Exhibit 8: Palace Theater

Exhibit 8B: Architectural Modifications

Exh. 8B Architectural Modifications to Palace Theater

8. PALACE THEATER PROMENADE ACCESSIBLE TOILET AND ENTRANCE PLAN

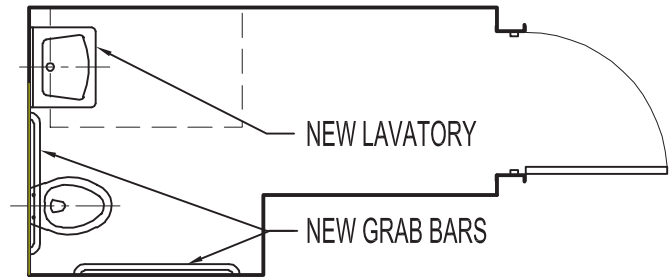
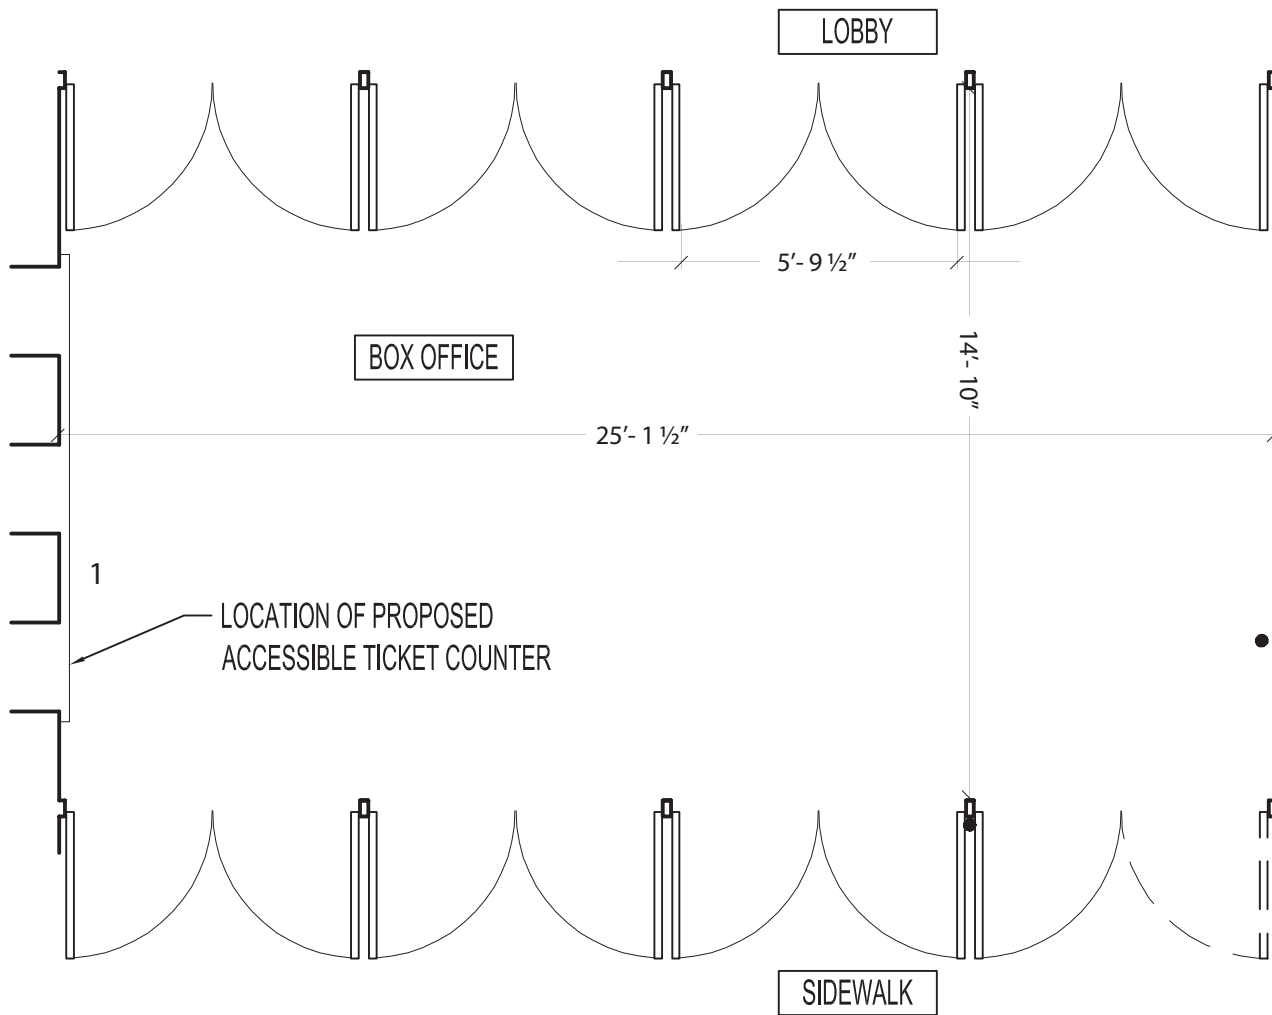
Nederlander shall maintain the entrance to the Theater, including but not limited to the automatic accessible entry doors, in the same condition as set forth on Exhibit 8A (i.e., in the same condition as they existed for the Government's inspection conducted on July 21, 2011).

DWG **8A.1**

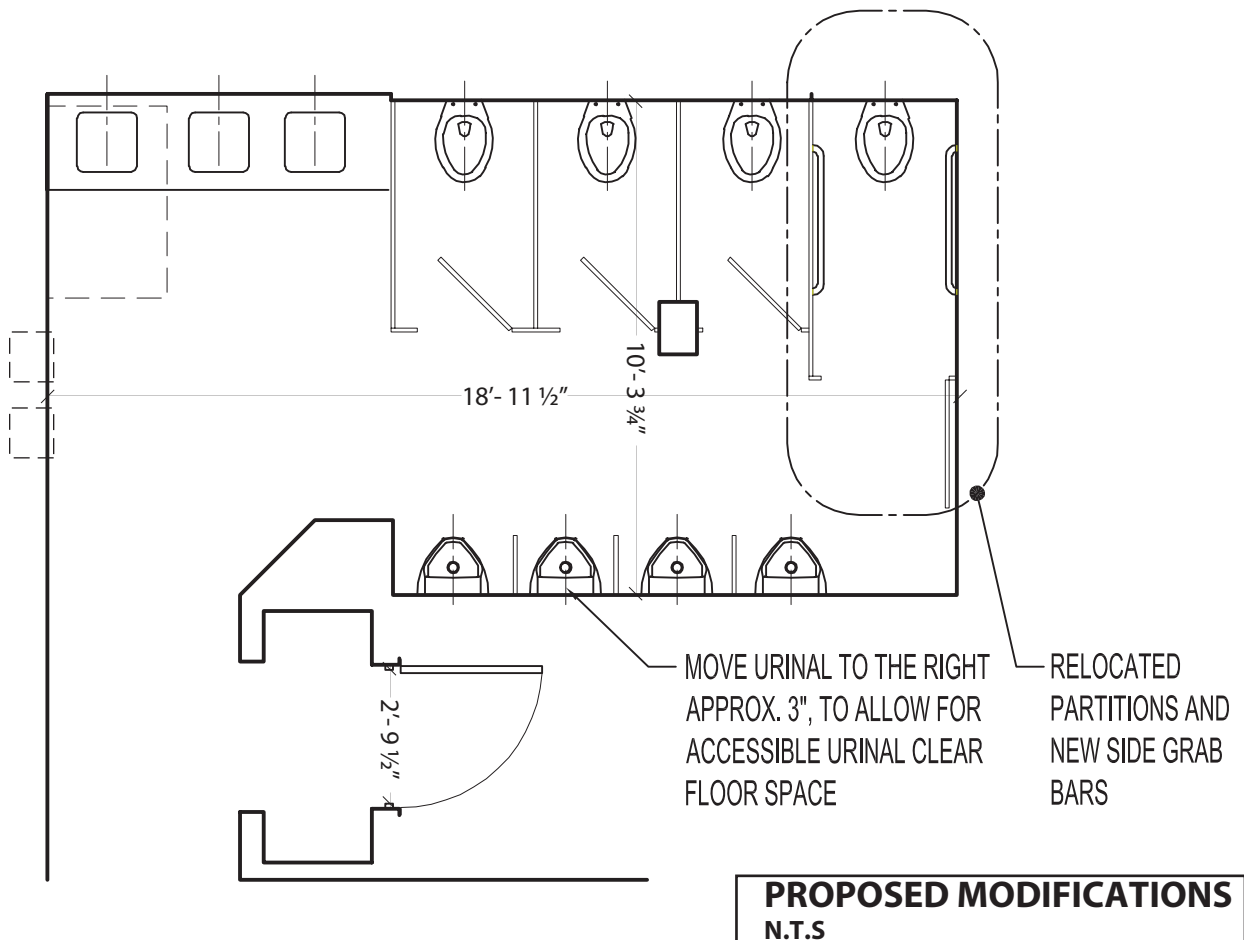
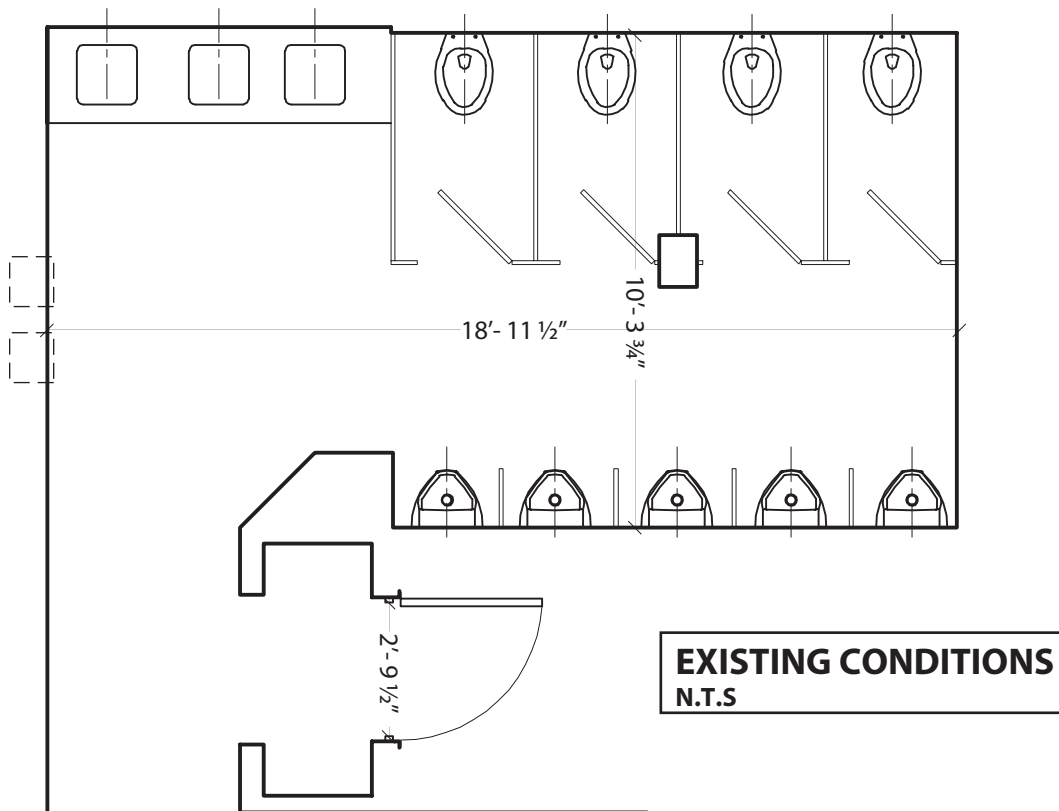
Line #	Location Description	Existing Condition	Barrier Removal	1991 Standards Reference	Architectural Modification
21	Promenade (Accessible Toilet Room)	The threshold has 1" total height.	Remove existing threshold, and install compliant threshold ($\frac{1}{4}$ " M height square, or $\frac{1}{2}$ " M height at 1:2 (50%) slope, except $\frac{3}{4}$ " M height at exterior sliding door).	4.1.3(7)(c) 4.1.6(3)(d)(ii) 4.13.8 4.5.2 Fig. 7(c,d)	Defendant will provide compliant threshold.
22	Promenade (Accessible Toilet Room)	Oddly shaped toilet room is 67" wide x 59" deep with a 47" wide x 58" long access corridor.	If technically feasible, modify existing fire walls at large column supporting hotel above as well as plumbing fixtures and accessories in this location to provide the minimum required turning space & clear width.	4.22.3 4.2.3 Fig. 3	Defendant will modify plumbing fixtures and accessories to provide the minimum required turning space and clear width.

23	Promenade (Accessible Toilet Room)	The door maneuvering clearance on the push side is 6" wide to the wall at the coat room.	Disable door closer or, unless technically infeasible, alter existing walls and/or relocate existing door and frame to obtain required maneuvering clearances.	4.13.6 Fig. 25(a-f)	Defendant will provide automatic door.
24	Promenade (Accessible Toilet Room)	The soap dispenser is mounted at 47" AFF over a 26" deep lavatory.	Replace lavatory with a standard lavatory to eliminate obstruction at dispenser or relocate existing soap dispenser within range.	4.1.3(11) 4.22.7 4.27 4.2.5 4.2.6	Defendant will provide compliant lavatory.
25	Promenade (Accessible Toilet Room)	The mirror is mounted at 47" AFF to the bottom of the reflecting surface.	Lower existing mirror or install full length mirror nearby.	4.1.3(11) 4.22.6 4.19.6	Defendant will provide compliant mirror.
26	Promenade (Accessible Toilet Room)	The side grab bar is 42" long, mounted at 44" AFF to the centerline and 4.5" from the rear wall.	Remove existing compliant side grab bar and remount in required location.	4.17.6 4.26 Fig. 29 Fig. 30 Fig. 39	Defendant will relocate side grab bar at appropriate mounting height.

Line #	Location Description	Existing Condition	Barrier Removal	1991 Standards Reference	Architectural Modification
27	Promenade (Accessible Toilet Room)	The rear grab bar is mounted at 41" AFF to the centerline. It is 24" long and mounted 5" from the side wall.	Remove existing rear grab bar and install new compliant rear grab bar. Coordinate with lavatory installation. Provide backing in wall as necessary.	4.17.6 4.26 Fig. 29 Fig. 30 Fig. 39	Defendant will provide and coordinate compliant rear grab bar with new lavatory.
28	Promenade (Accessible Toilet Room)	The flush mechanism is on the narrow side of the water closet.	Install new flush valve with handle on opposite side or automatic flush mechanism.	4.16.5	Defendant will provide and coordinate compliant rear grab bar with new lavatory.
29	Promenade (Accessible Toilet Room)	The door requires 6 pounds of force to open.	Adjust or replace existing closer to provide compliant speed and force.	4.1.3(7)(c) 4.13.10	Defendant will provide automatic door.

30	Promenade (Accessible Toilet Room)	There is no raised lettering and Braille room identification sign provided at this unisex single user toilet room.	Install compliant signage in the required location.	4.1.3(16)(a) 4.30.1 4.30.4 4.30.5 4.30.6	Defendant will provide compliant signage.
31	Stairs (to Lower Level Men's Multi-user Toilet Room)	There is a section near the bottom of the first run of stairs with only 71" AFF of headroom.	If technically infeasible to alter structural element to provide required vertical clearance, consider adding padding and paint or install low headroom warning signs on beam.	4.4.2 Fig. 8(a,c-1)	Defendant will provide compliant padding and signage.

DWG **8A.2**

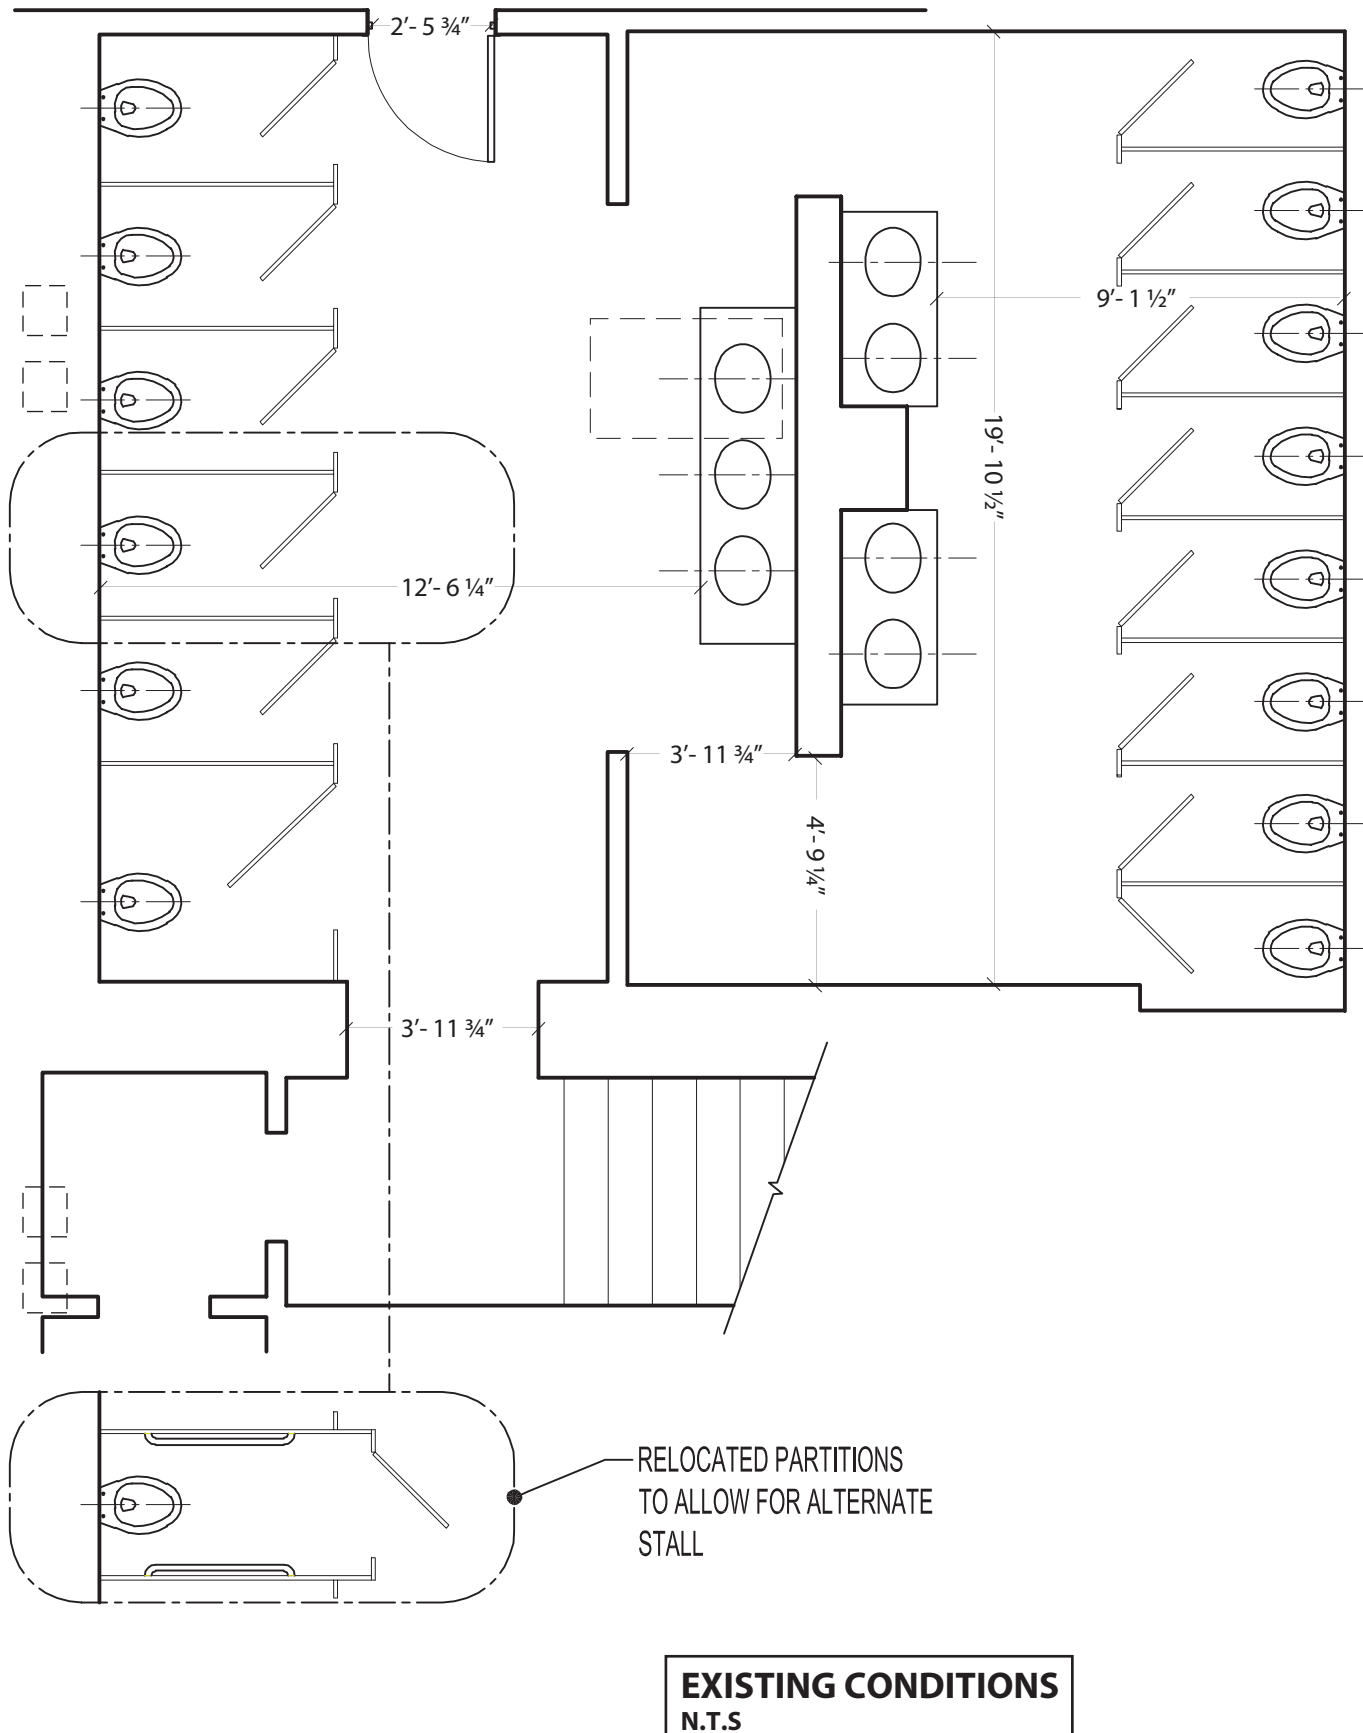
Line #	Location Description	Existing Condition	Barrier Removal	1991 Standards Reference	Architectural Modification
7	Lower Level (Men's Multi-user Toilet Room)	There are 4 stalls and 5 urinals in this toilet room. None of the stalls have grab bars or provide any accessible features.	No accessible stall exists: convert typical stall into standard accessible stall. Modification may require removal of one water closet, if allowed by plumbing code. Install grab bars for standard or alternate accessible stall if standard accessible stall cannot be provided. If standard accessible stall is not provided, install directional sign to accessible toilet.	4.1.3(11) 4.22	Defendant will provide alternate accessible stall and compliant signage to standard accessible toilet.
8	Lower Level (Men's Multi-user Toilet Room)	There are 3 lavatories with base cabinets that obstruct knee clearance.	Modify(y)existing lavatory and counter to provide a compliant counter and lavatory.	4.1.3(11) 4.22.6 4.19.2 Fig. 31	Defendant will provide compliant lavatory.

9	Lower Level (Men's Multi-user Toilet Room)	The toilet room is located on an inaccessible level.	Provide directional sign(s) to accessible toilet rooms in obvious location(s) on orchestra level.	4.1.6(3)(e)(iii)	Defendant will provide compliant signage.
10	Lower Level (Men's Multi-user Toilet Room)	There are 2 telephones mounted at 57" AFF to the highest operable part.	Remove or relocate existing compliant phone within reach range.	4.1.3(17) 4.31.2 4.31.3 4.31.4 4.31.5 4.31.6 4.31.7 4.31.8 4.30.7 Fig. 44 4.2.4 4.2.5 4.2.6 4.4 4.1.3	Defendant will remove telephones.

Line #	Location Description	Existing Condition	Barrier Removal	1991 Standards Reference	Architectural Modification
11	Lower Level (Men's Multi- user Toilet Room)	The paper towel dispenser is mounted at 50" AFF.	Verify that side approach clear floor space is available or install new towel dispenser within reach range where required clear floor space is available. Existing noncompliant towel dispenser may remain.	4.1.3(11) 4.22.7 4.27.3	Defendants will provide compliant mounting height.
12	Lower Level (Women's Multi-user Toilet Room)	There are 14 stalls in this toilet room. One stall is 55" wide x 60" deep and has parallel grab bars. The water closet is mounted 24" from the narrow side wall. The stall door swings in. Swinging the stall door out might create a traffic flow problem due to the location of this water closet.	No accessible stall exists: convert one typical stall into a compliant standard accessible stall or a 36" wide alternate stall.	4.1.3(11) 4.22 4.16 4.17 Fig. 28 Fig. 30	Defendant will provide alternate accessible stall.

8. PALACE THEATER LOWER LEVEL WOMEN'S MULTI-USER TOILET ROOM PLAN

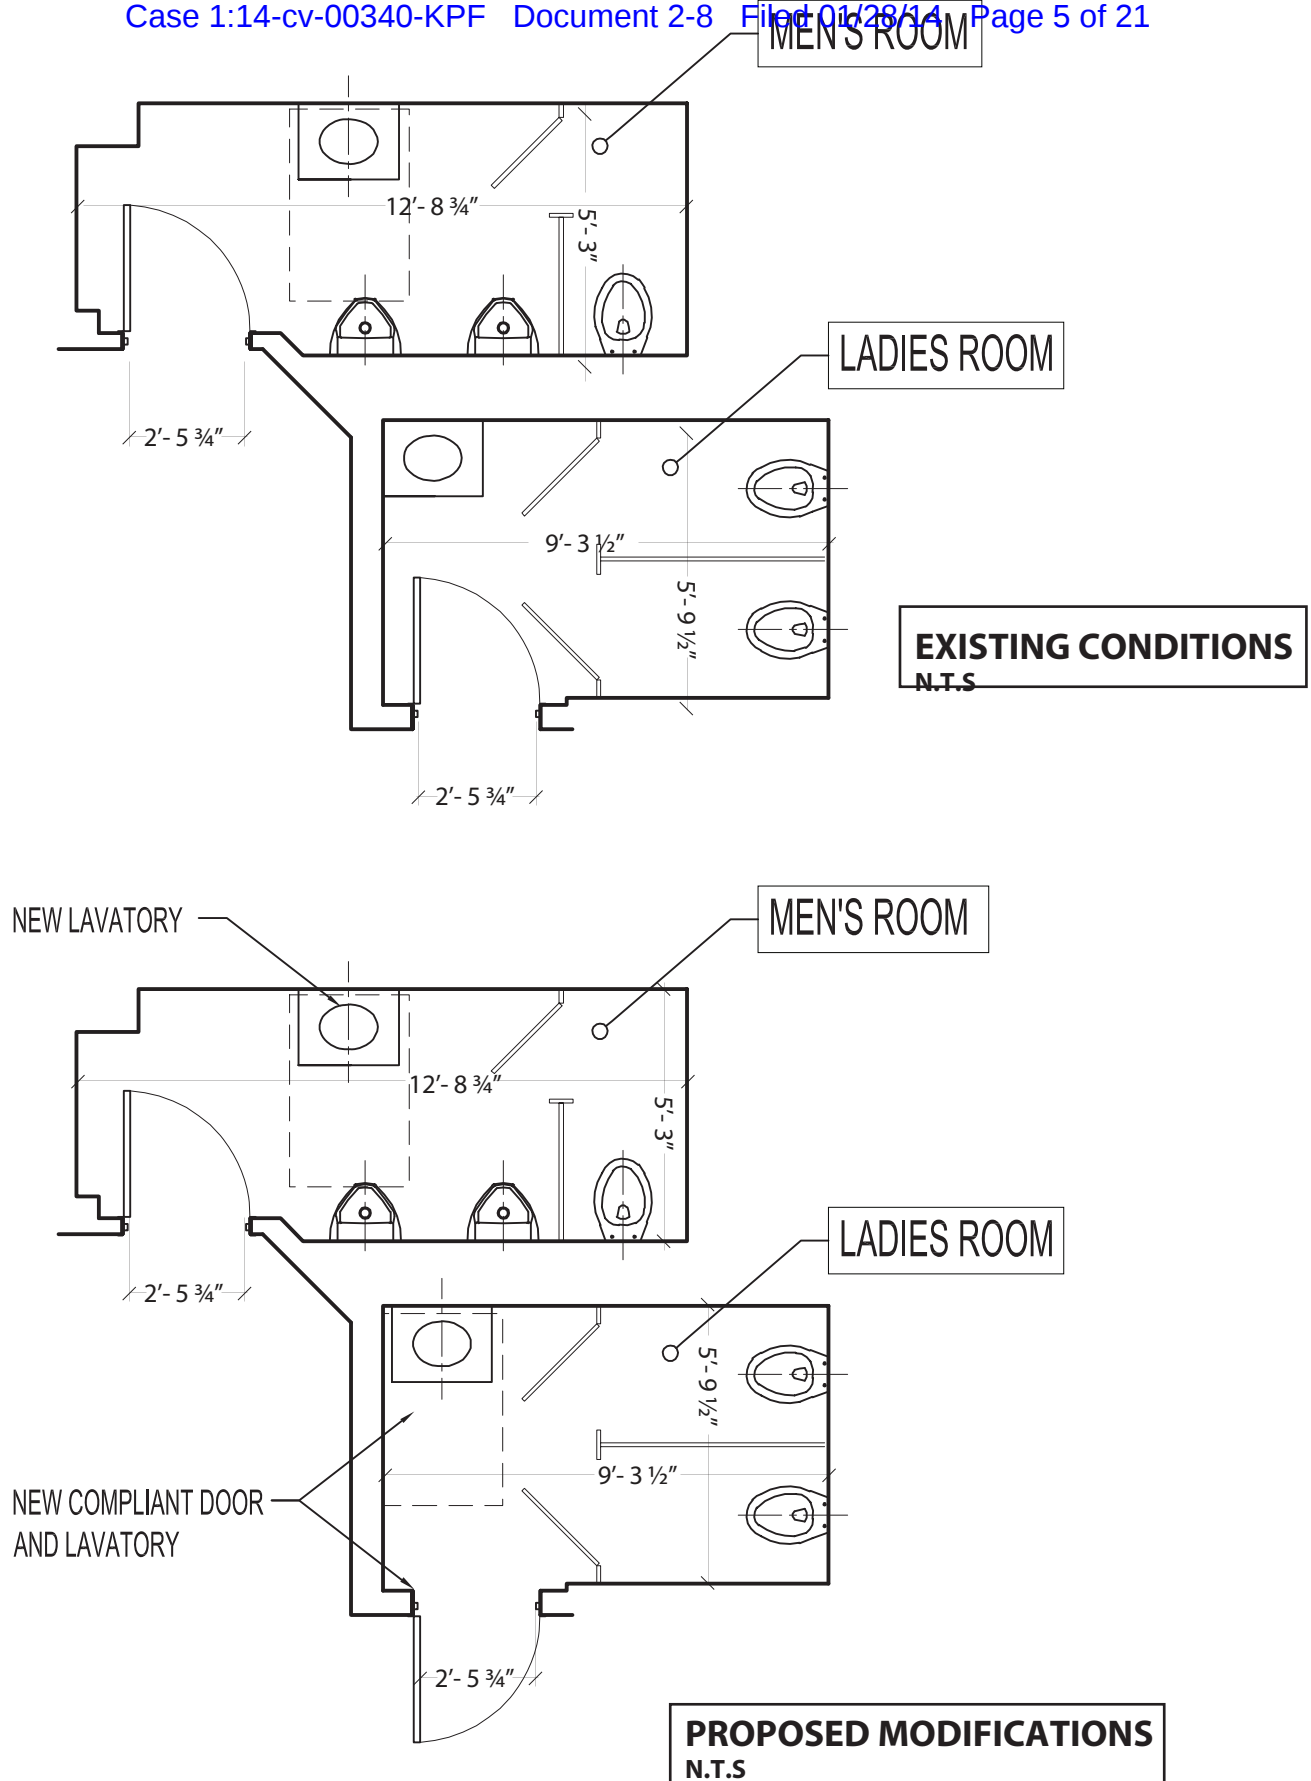
13	Lower Level (Women's Multi-user Toilet Room)	The coat hook is mounted at 65" AFF.	Install an additional coat hook within reach range.	4.22.7 4.23.7 4.27.3 4.2.5 4.2.6 Fig. 5 Fig. 6	Defendant will provide compliant mounting height of coat hook.
14	Lower Level (Women's Multi-user Toilet Room)	There are 7 lavatories with base cabinets that obstruct knee clearance.	Modify existing lavatory and counter to provide a compliant counter and lavatory.	4.1.3(11) 4.22.6 4.19.2 Fig. 31	Defendant will provide compliant lavatory.
15	Lower Level (Women's Multi-user Toilet Room)	There is one visual alarm mounted on the ceiling and one mounted near the ceiling, both are frosted.	When alarm system is upgraded or replaced, provide compliant visual signal(s) integrated with the existing audible alarm system.	4.1.3(14) 4.28	No alarm system upgrades are scheduled at this time.

Line #	Location Description	Existing Condition	Barrier Removal	1991 Standards Reference	Architectural Modification
16	Lower Level (Women's Multi-user Toilet Room)	There is no raised lettering and Braille room identification sign provided at this gender specific multi-user toilet room.	Install compliant signage in the required location.	4.1.3(16)(a) 4.30.1 4.30.4 4.30.5 4.30.6	Defendant will provide compliant signage.
17	Lower Level (Women's Multi-user Toilet Room)	The telephone is mounted at 57" AFF to the highest operable part.	Remove or relocate existing compliant phone within reach range.	4.1.3(17) 4.3 4.30.7 Fig. 44 4.2.4 4.2.5 4.2.6 4.4	Defendant will remove the telephones.
18	Lower Level (Women's Multi-user Toilet Room)	The toilet room is located on an inaccessible level.	Provide directional sign(s) to accessible toilet rooms in obvious location(s) on orchestra level.	4.1.6(3)(e)(iii)	Defendants will provide compliant signage.
